E5071C-31B

Information Only Service Note

E5071C ENA Series Network Analyzer

E5071C LCD Touch Panel Display Assembly Replacement Part Change

Figure 1-1

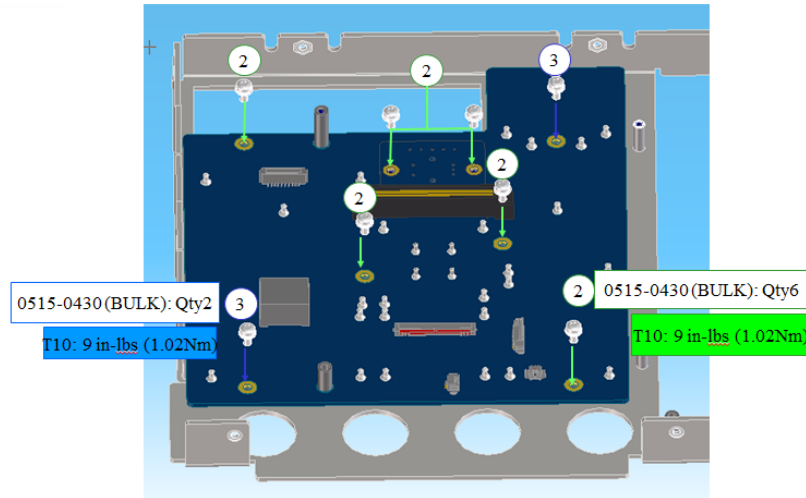
1. Install the keyboard on the new front panel sub as shown in figure 1-1.

Note: The front panel, panel sub and cover shield are required to be replaced due to dimension changes. Front panel frequency label should be purchased separately according to unit frequency options.

Figure 1-2

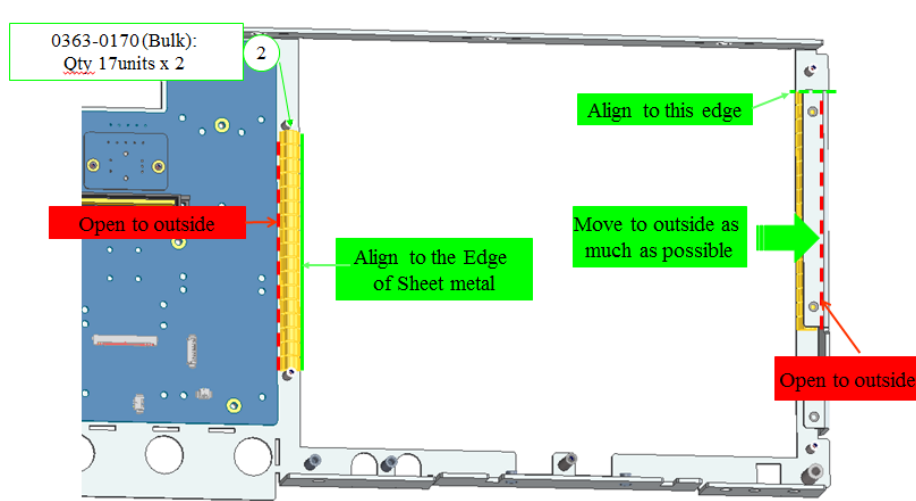
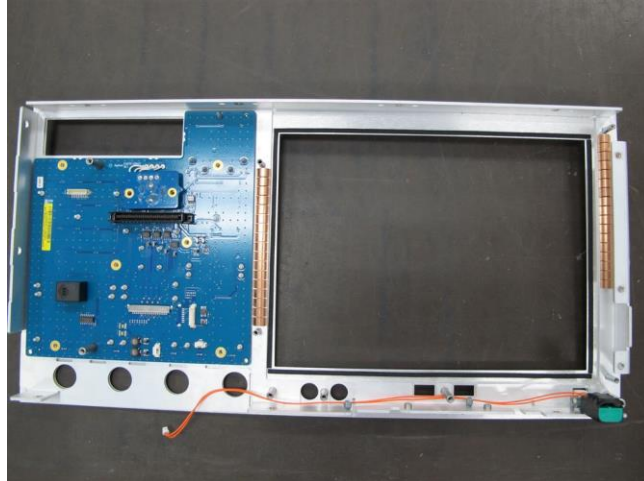
2. Install the gaskets as shown in Figure 1-2. Figure 1-3 illustrates the Front panel with the keyboard installed.

Figure 1-4

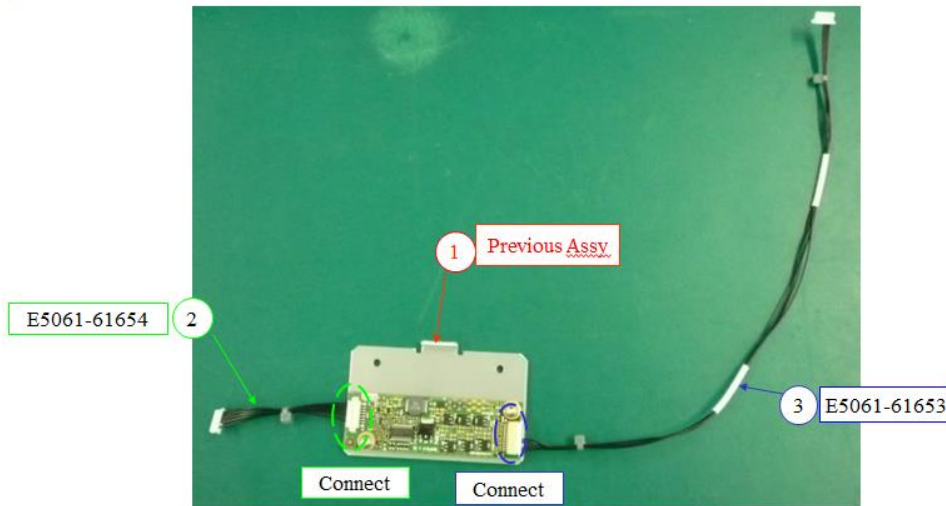
3. Install the inverter on the bracket before connect the cable assembly to both ends as shown in figure 1-4

Figure 1-5

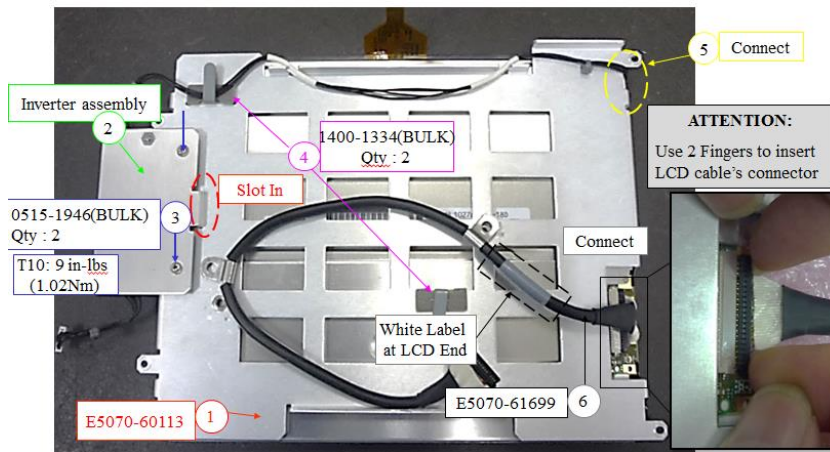
4. Install the inverter assembly onto the new CLD T/P display assembly (with LED backlight). Refer to figure 1-5 for details.

Figure 1-6

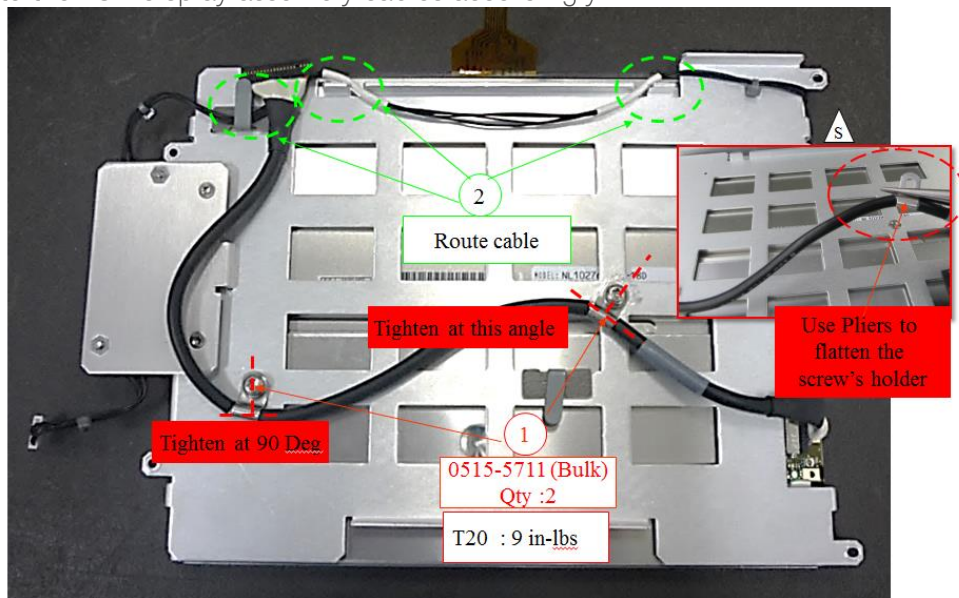
5. Route the LCD display assembly cables accordingly.

Figure 1-7

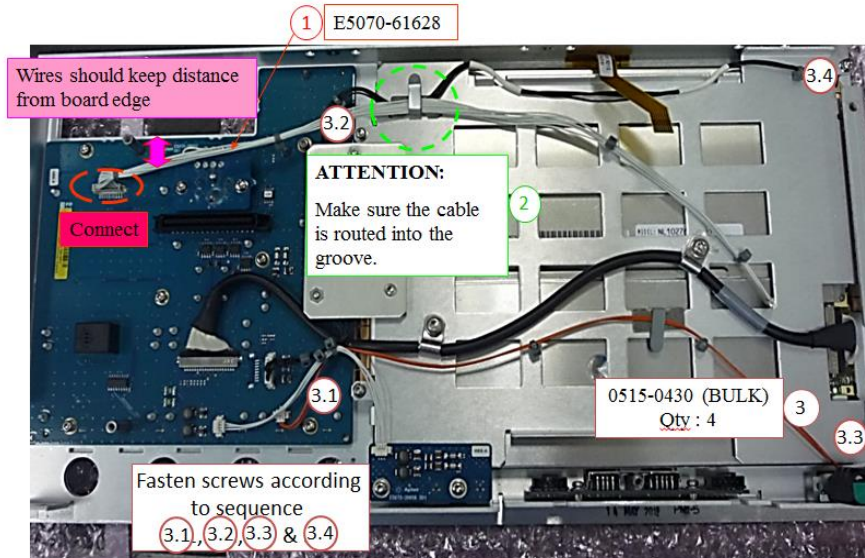
6. Install the LCD T/P Display Assembly onto the LCD Front Panel. Fasten the screws according to the following sequence. Connect all cable assemblies as shown in figure 1-7.

Figure 1-8

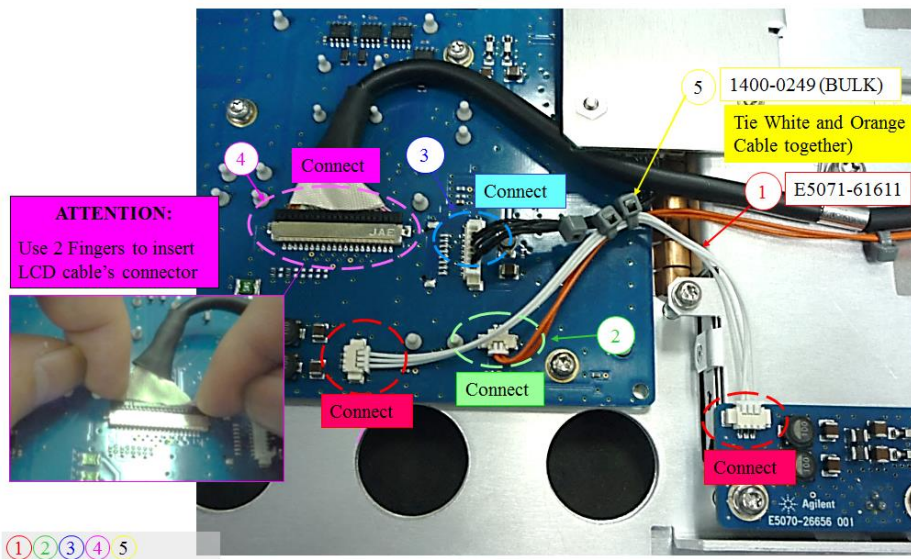
7. Connect the cable assemblies to the keyboard.

Figure 1-9

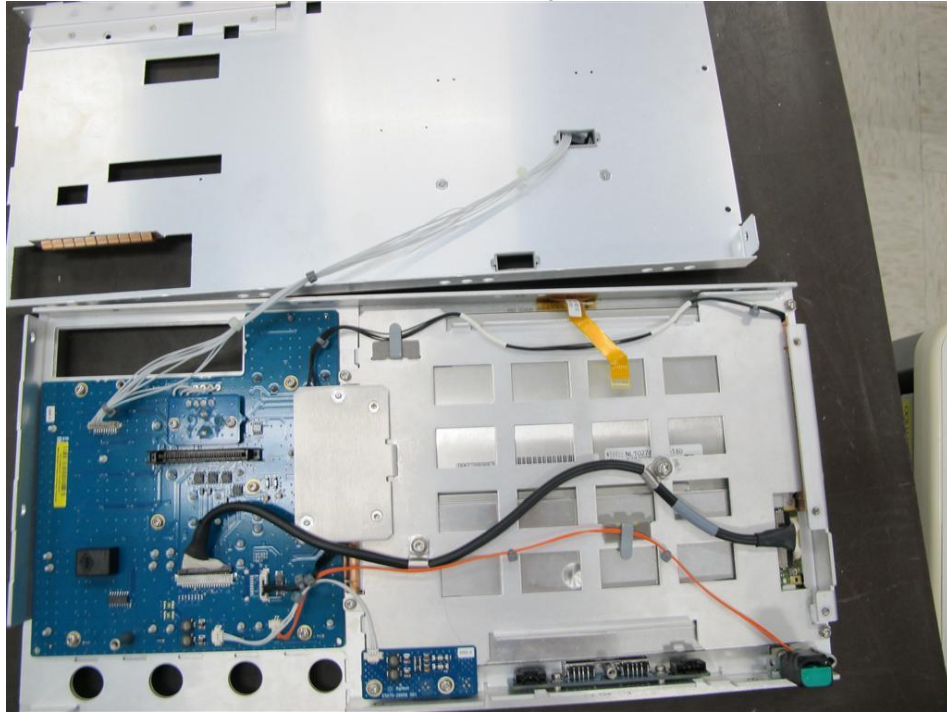
8. Shown would be the completed installation of the assemblies. Kindly ensure the connections of the cable assemblies are good and properly secured. Fasten the six screws in securing the shield (back cover) to the Front Panel Assembly.

Figure 1-10

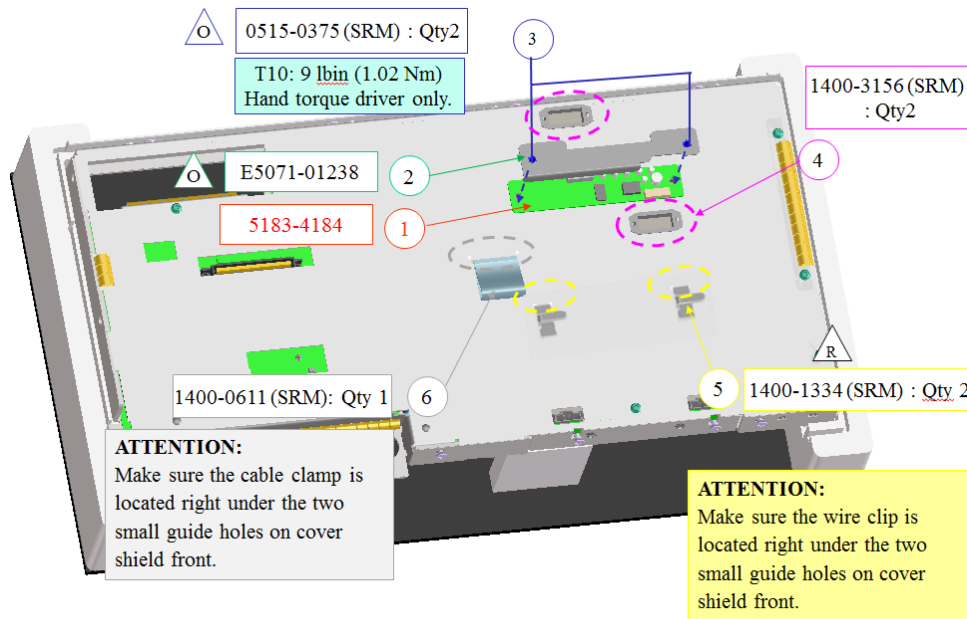
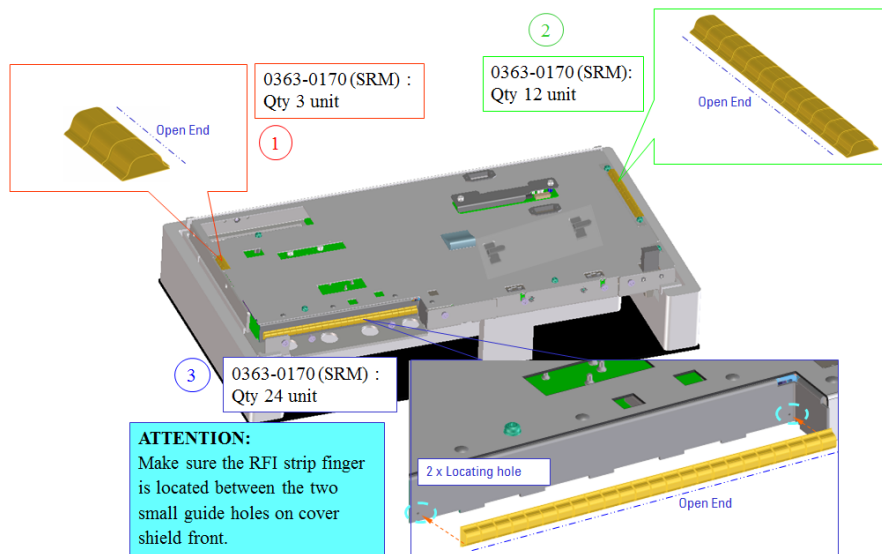
9. On Front Panel assembly shield (back cover), install the touch panel controller and the required cable clamps and gasket. Refer to figure 1-10, 1-11 for details.

Figure 2-1

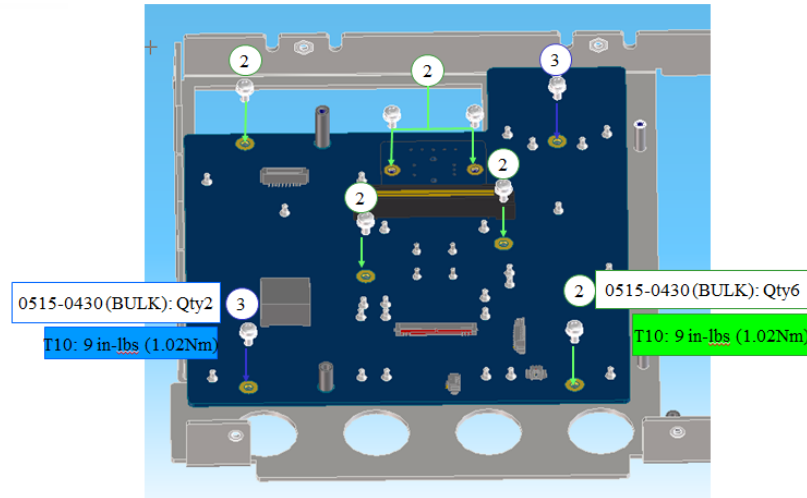
1. Install the keyboard on the new front panel sub as shown in figure 2-1.

Note: The front panel, panel sub and cover shield are required to be replaced due to dimension changes. Front panel frequency label has to be purchased separately according to unit frequency options.

Figure 2-2

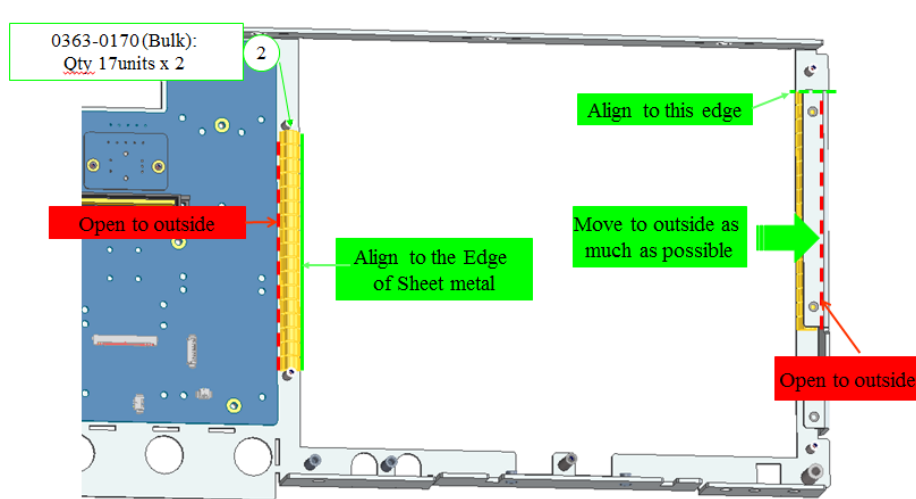
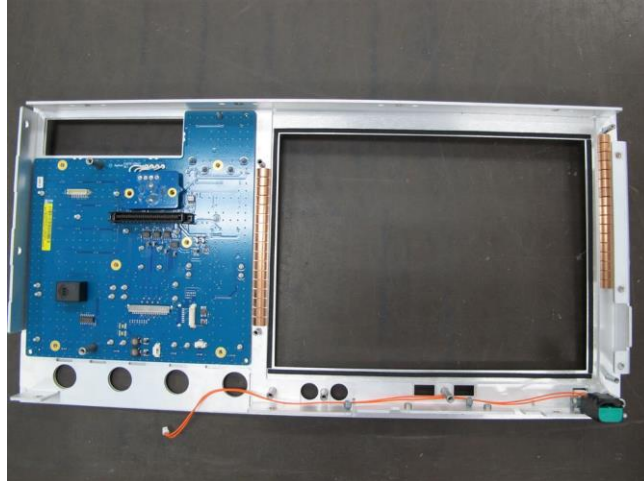
2. Install the gaskets as shown in Figure 2-2. Figure 2-3 illustrates the Front panel with the keyboard installed.

Figure 2-4

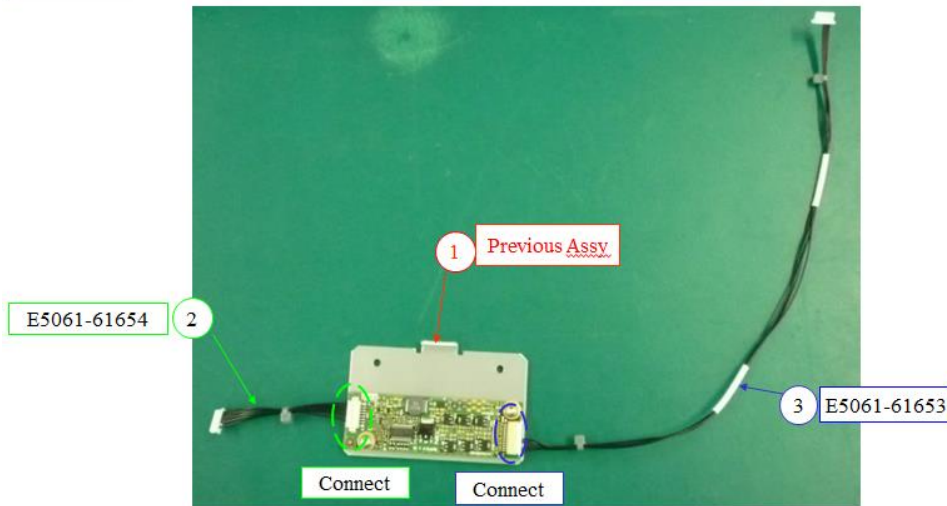
3. Install the inverter on the bracket before connect the cable assembly to both ends as shown in figure 2-4

Figure 2-5

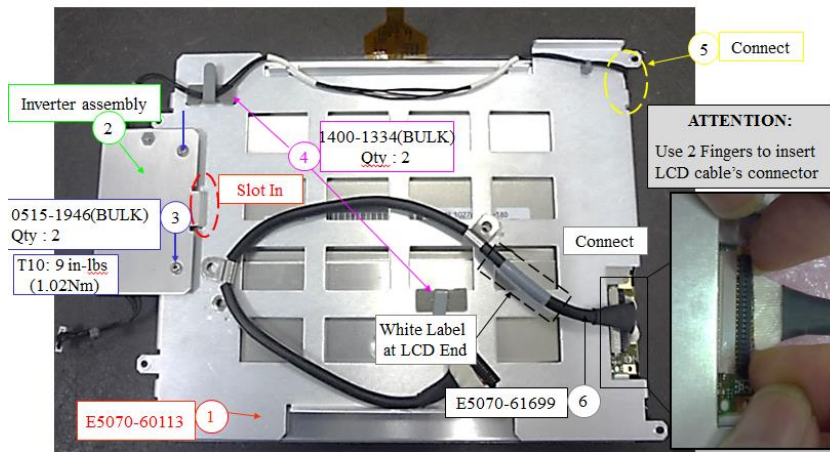
4. Install the inverter assembly onto the new CLD T/P display assembly (with LED backlight). Refer to figure 2-5 for details.

Figure 2-6

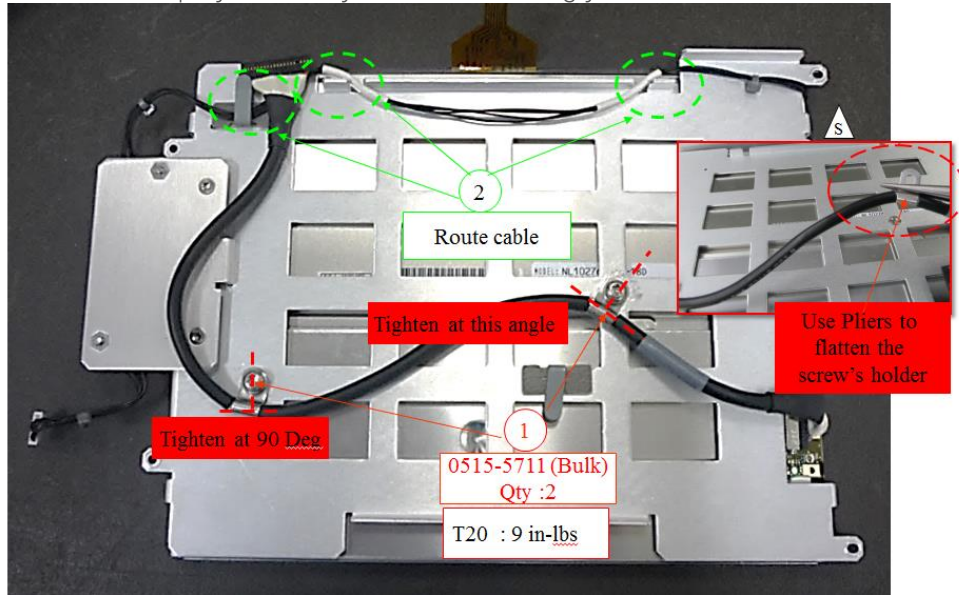
5. Route the LCD display assembly cables accordingly.

Figure 2-7

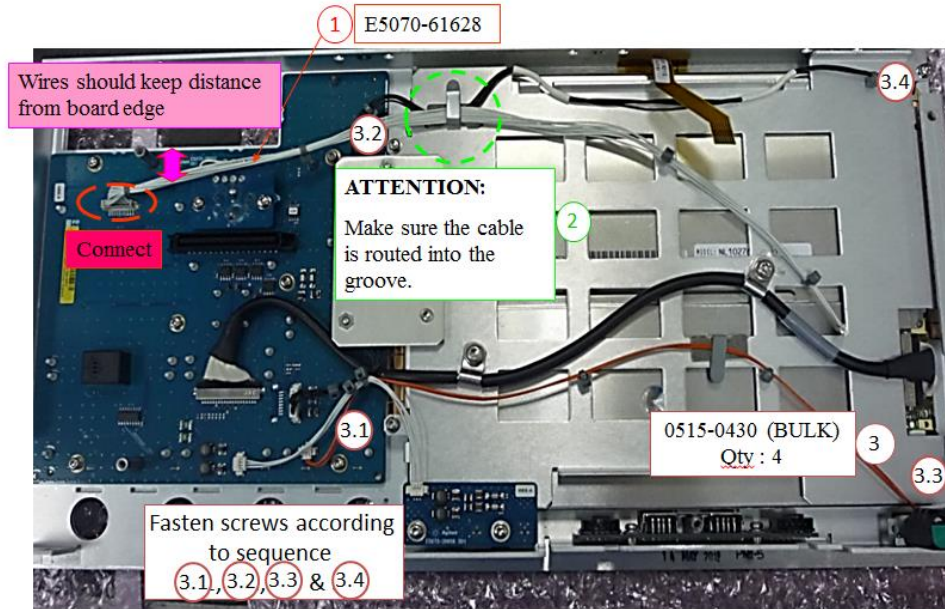
6. Install the LCD T/P Display Assembly onto the LCD Front Panel. Fasten the screws according to the following sequence. Connect all cable assemblies as shown in figure 2-7.

Figure 2-8

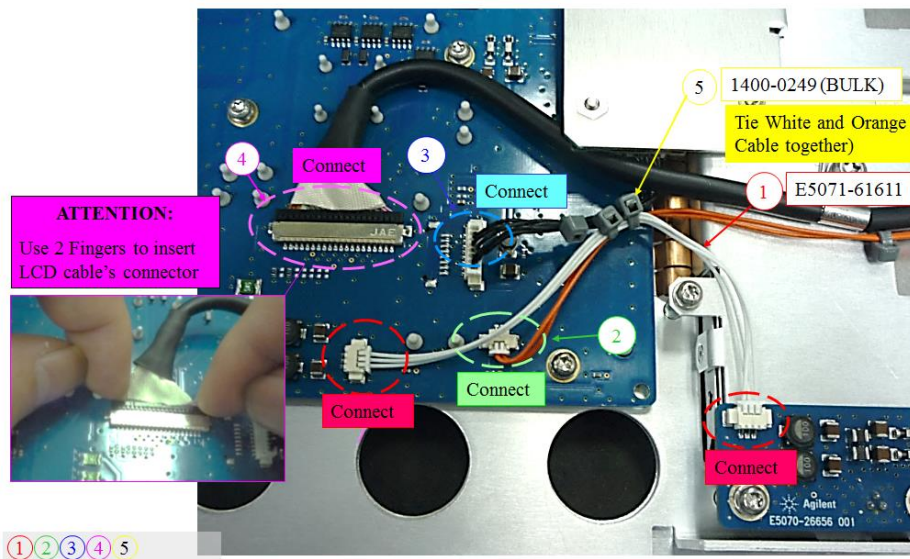
7. Connect the cable assemblies to the keyboard.

Figure 2-10

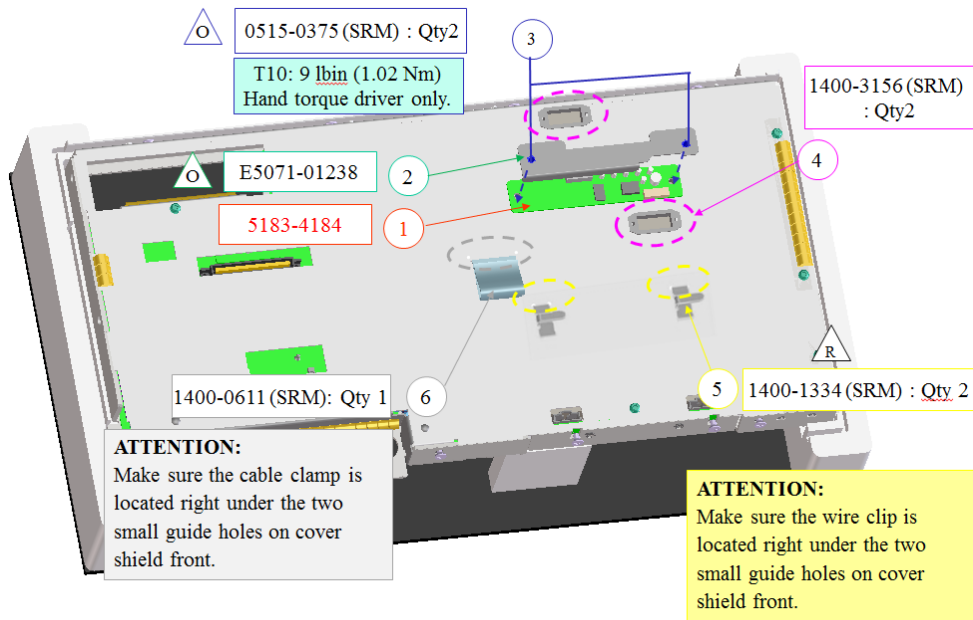
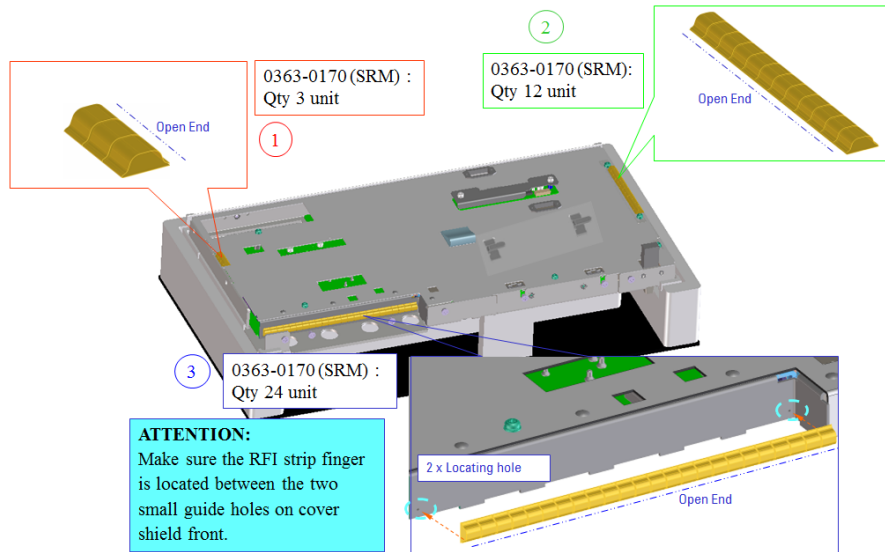
9. On Front Panel assembly shield (back cover), install the touch panel controller and the required cable clamps and gasket. Refer to figure 2-10, 2-11 for details.
